SERVICE BULLETIN

TS-940S AVR UNIT CAPACITOR CHANGE

4-8-86

AVR UNIT (X43-1500-00) Component side view

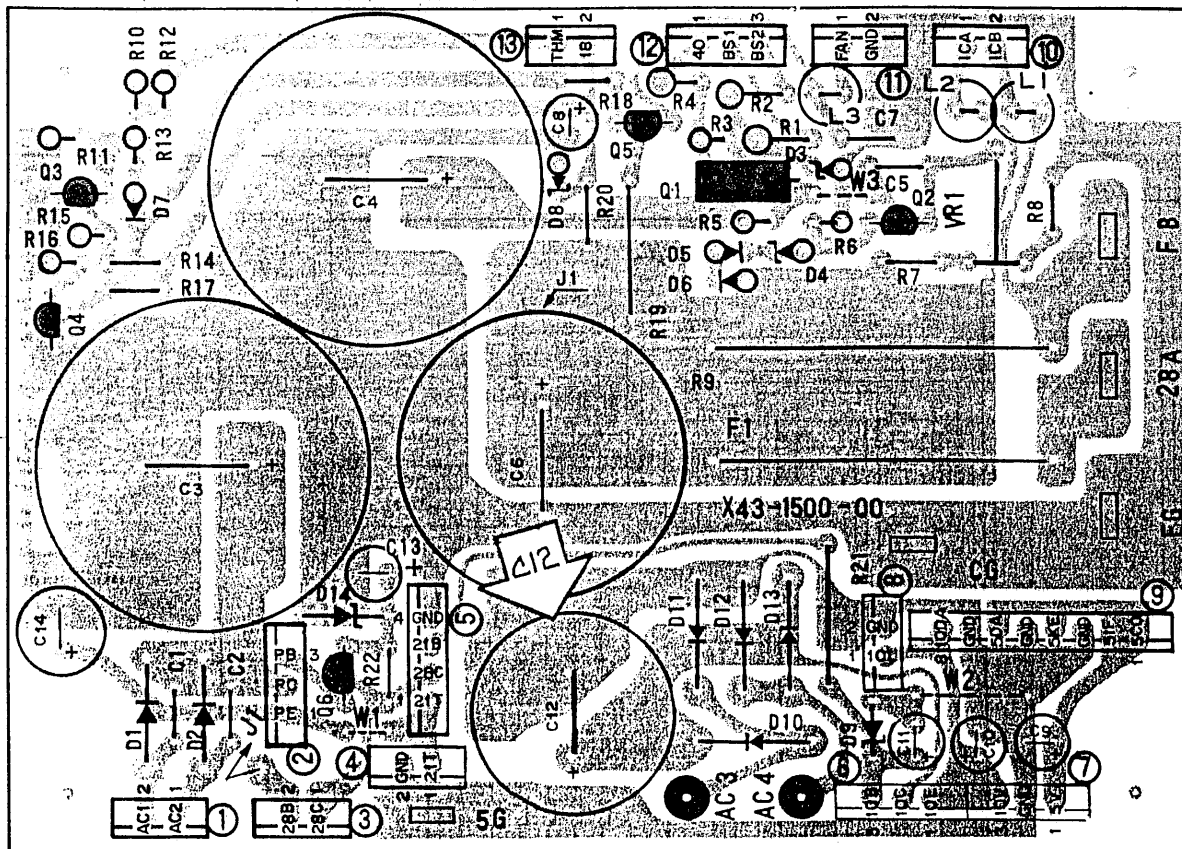
In those areas of the country that are subject to large power line voltage fluctuations, excessive voltage may be applied to capacitor C12 on the AVR Unit (X43-1500-00). These voltage fluctuations might exceed the capacitor breakdown voltage. Replacing capacitor C12 with a capacitor having a higher breakdown voltage will help prevent this potential problem.

On the AVR Unit (X43-1500-00) change C12 from a 6800 μ F capacitor to a 5600 μ F 25 v capacitor (C90-2037-05).
